HISTORIC AND DESIGN REVIEW COMMISSION

HDRC CASE NO: 2015-324
ADDRESS: 434 FURR DR
LEGAL DESCRIPTION: NCB: 6696 BLK: 5 LOT: 28
ZONING: R6 H
CITY COUNCIL DIST.: 7
DISTRICT: Monticello Park Historic District
APPLICANT: Nicole McLeod
OWNER: Nicole McLeod
TYPE OF WORK: Final approval of accessory structure modifications
REQUEST:

The applicant is requesting a Certificate of Appropriateness for approval to rehabilitate the rear accessory structure at 434 Furr.

FURR DR. RESIDENCE

SHEET
A2
9-2015

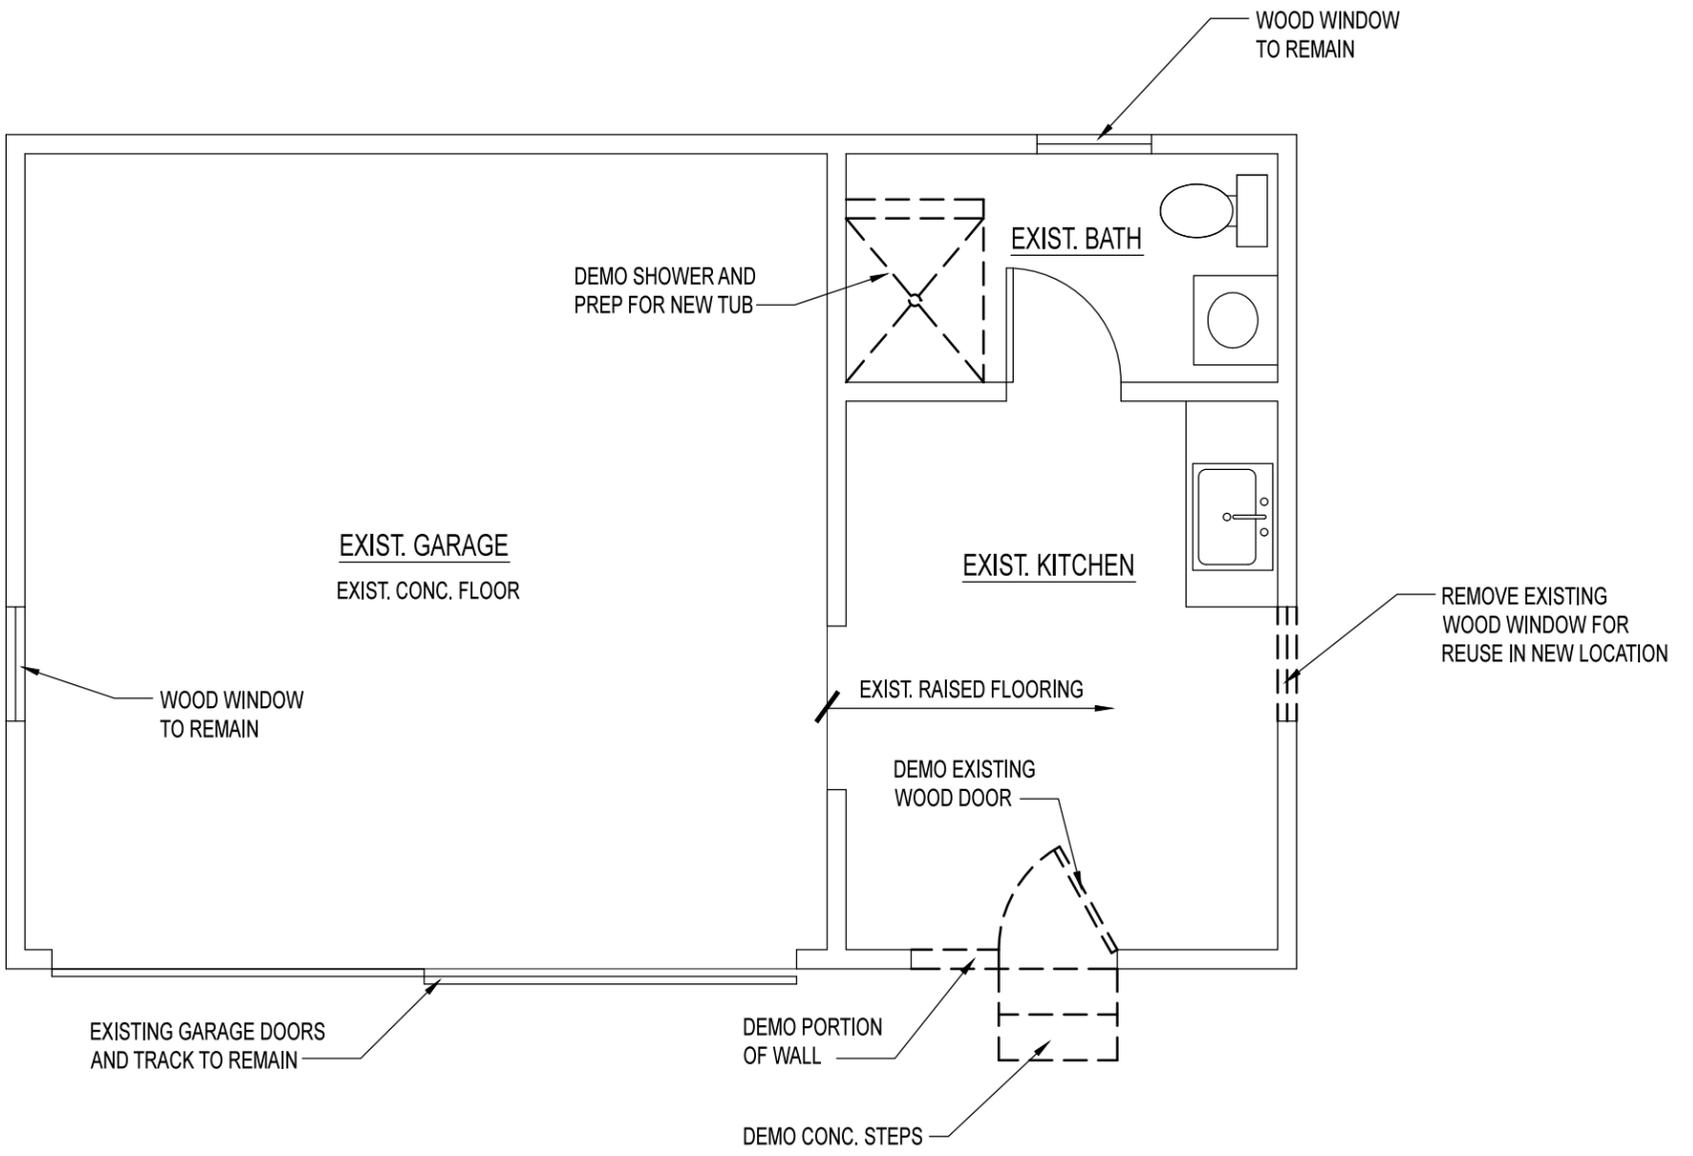
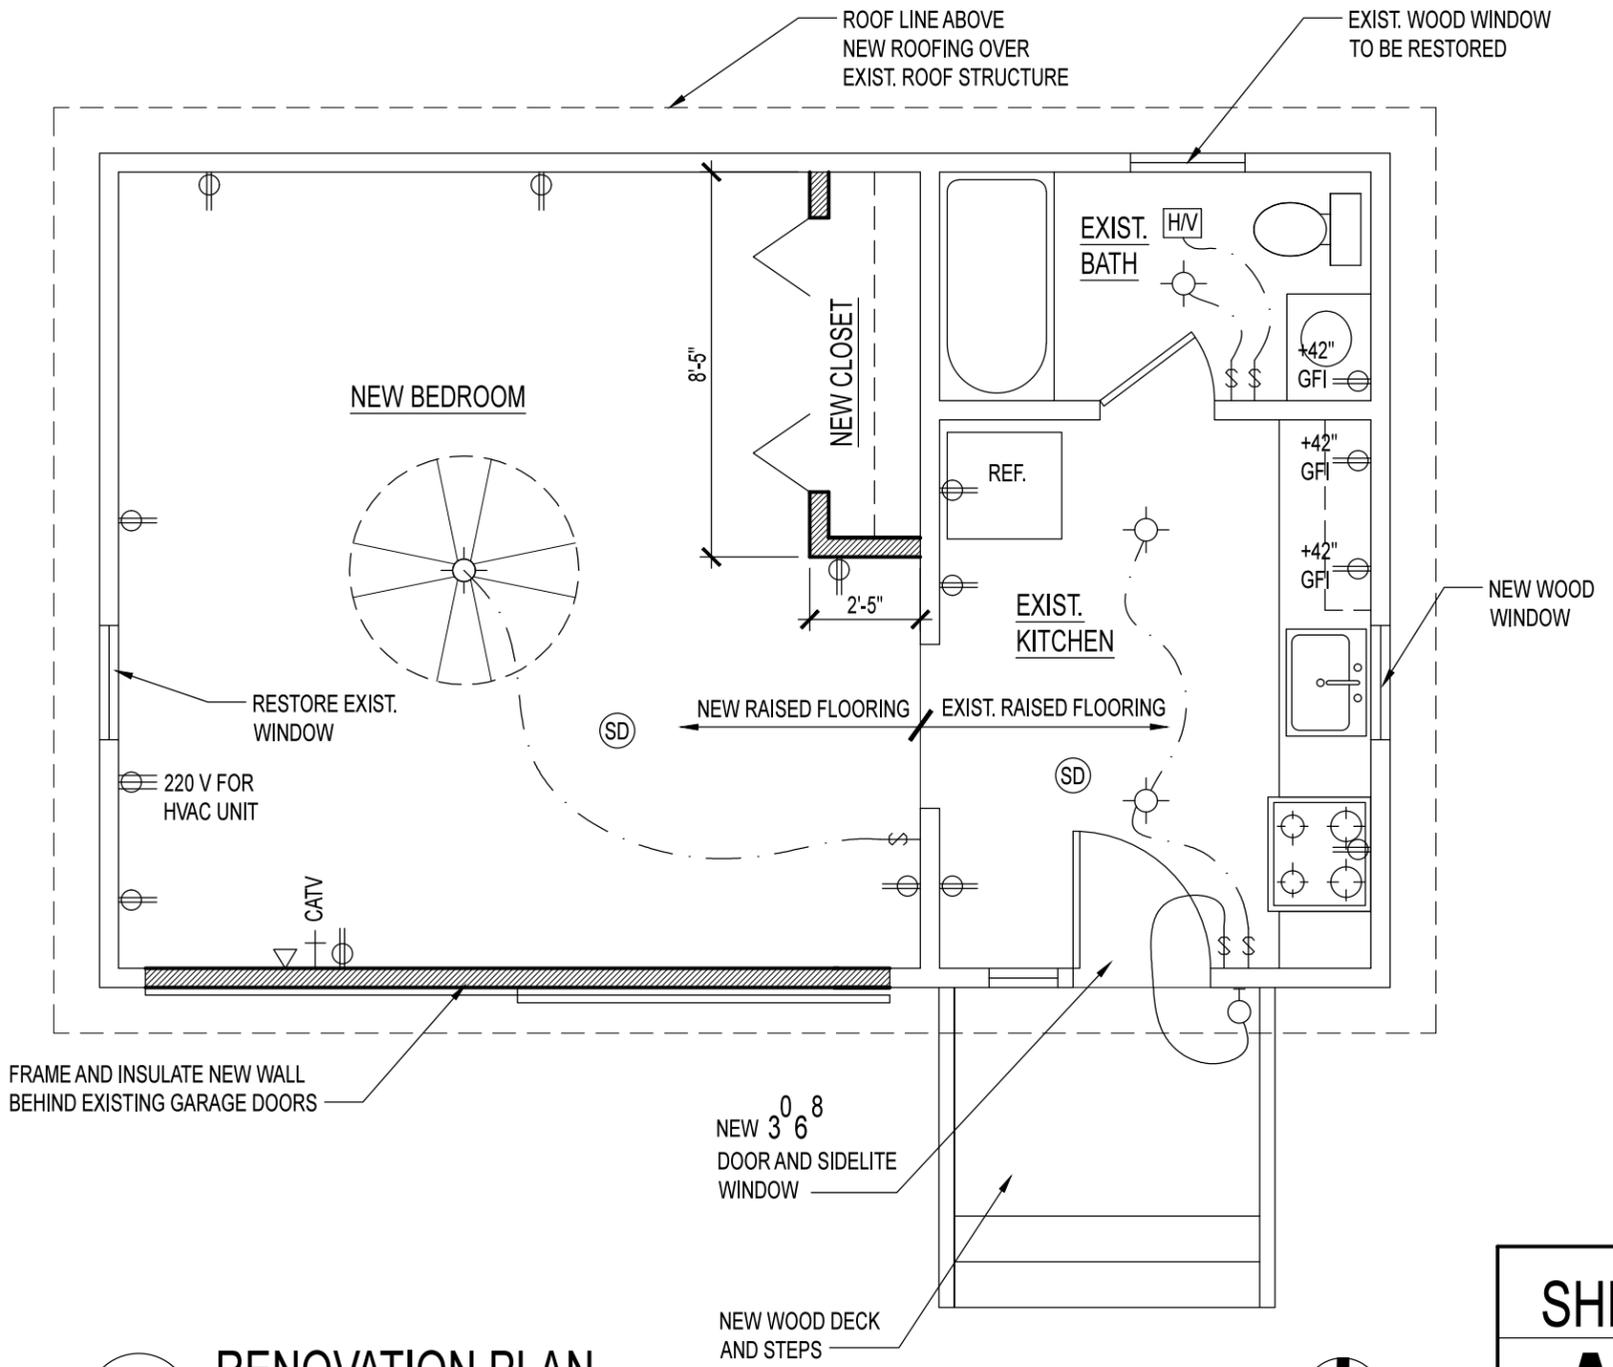
- b. The applicant has proposed to rehabilitate the rear accessory structure at 434 Furr. Within this rehabilitation, the applicant has proposed to remove the existing wood siding and replace with Hardi Board siding, install new attic vents, install a new door and sidelight, install wood front deck and steps, install a new shingle roof and construct a wall behind the existing carriage doors.

- e. The applicant has proposed to install a new, wider front door as well as a sidelight to the left of the door. Given its

- location where it will not be viewed from the public right of way and the narrow width of the existing front door, staff finds this request appropriate. If possible, staff recommends that the applicant salvage the existing wood door.

- f. The applicant has noted that the new raised floor will be approximately one foot above grade. The applicant has proposed to install a front porch deck and railing to accommodate access to the raised finish floor and front door. The applicant has noted that the proposed deck will be wood. Staff finds this proposal appropriate and consistent with the materials proposed throughout the project.

- i. That the applicant restore the existing wood siding and not replace it in whole.
- ii. That the applicant restore both wood windows rather than only one.
- iii. That the applicant make an attempt to salvage the existing wood door.

1 NORTH ELEVATION

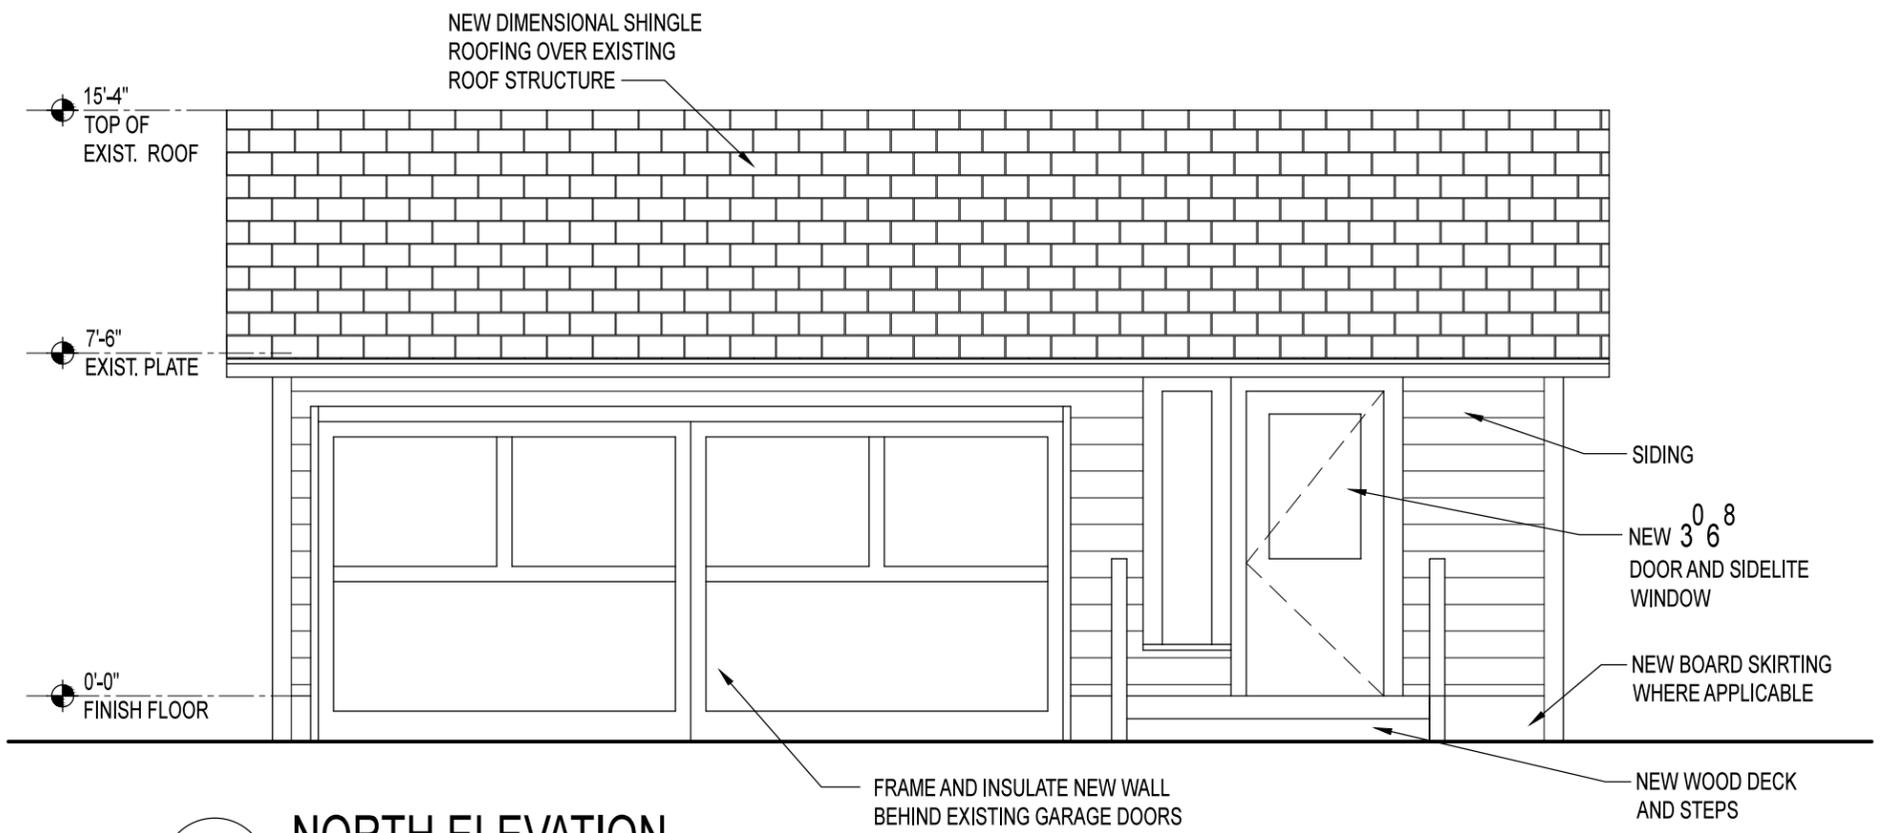
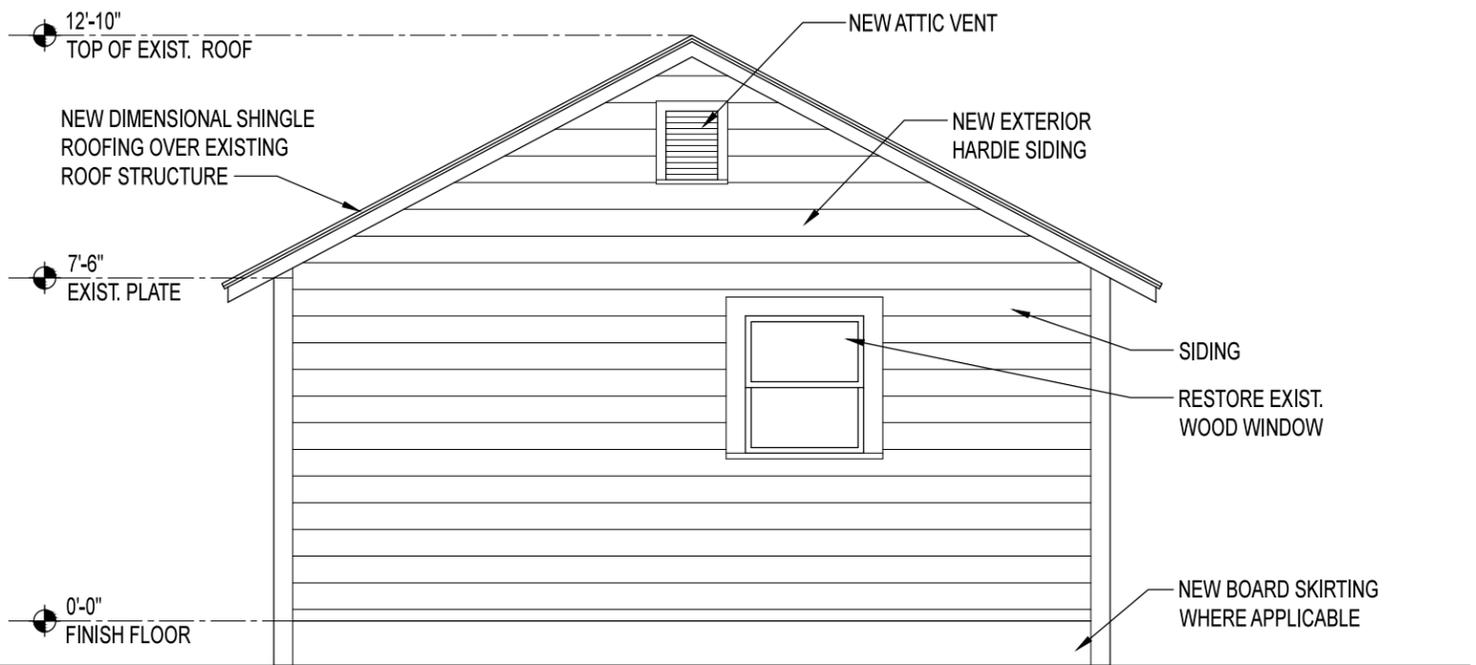
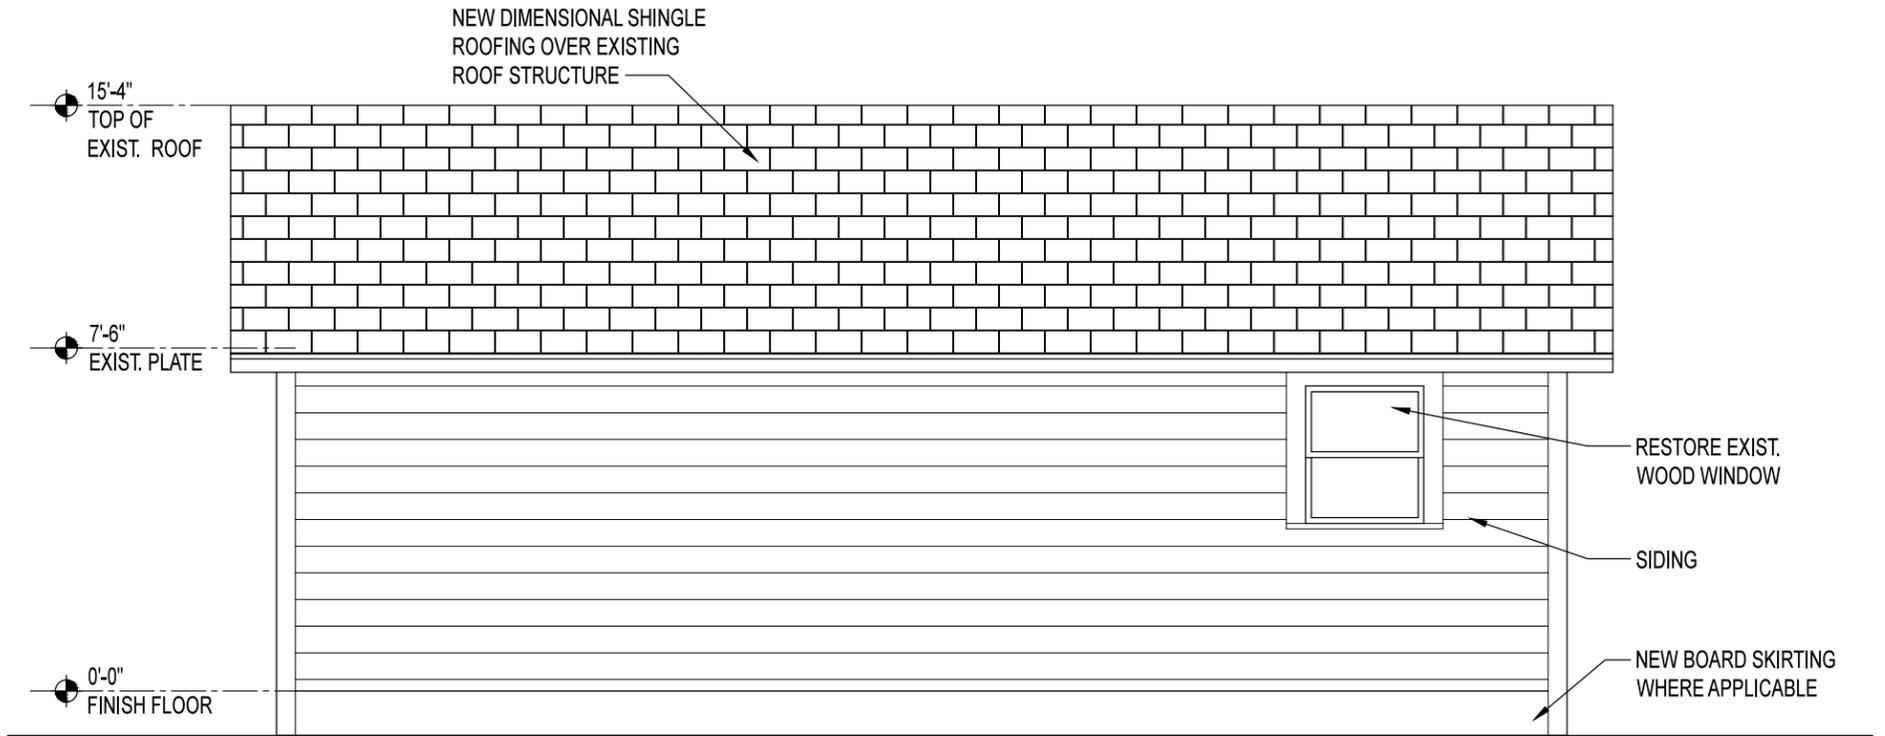
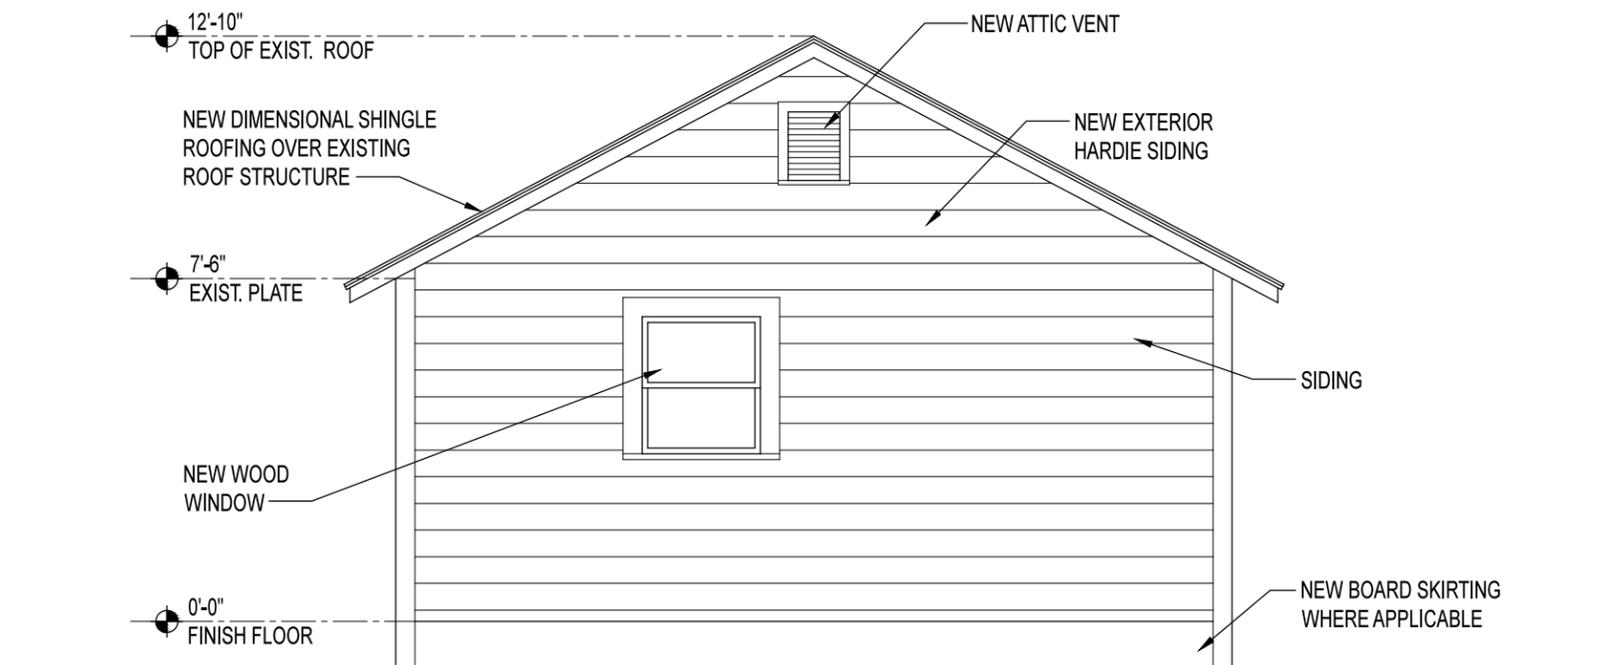
- d. The Guidelines for Exterior Maintenance and Alterations 9.A.ii., existing historic materials should be repaired. If existing materials are beyond repair, new materials that match the existing in color, durability and texture should be used. Staff does not find the wholesale replacement of the existing wood siding appropriate. Staff recommends that the applicant repair the existing siding and replace what is damaged beyond repair.

- g. The applicant has noted that one of the existing wood windows is to be restored while the other is to be replaced. Per the Guidelines for Exterior Maintenance and Alterations, wood windows should be repaired unless they are damaged beyond repair. If this is the case, staff recommends the applicant provide information to that effect.

- h. The applicant has proposed to restore the existing wood carriage doors and frame and insulate a new wall in the existing door openings. The applicant's proposal to retain the existing carriage doors is consistent with the Guidelines for Exterior Maintenance and Alterations 9.B.i. In this case, staff finds the framing of the existing openings appropriate given this accessory structure's location at the rear of the lot.
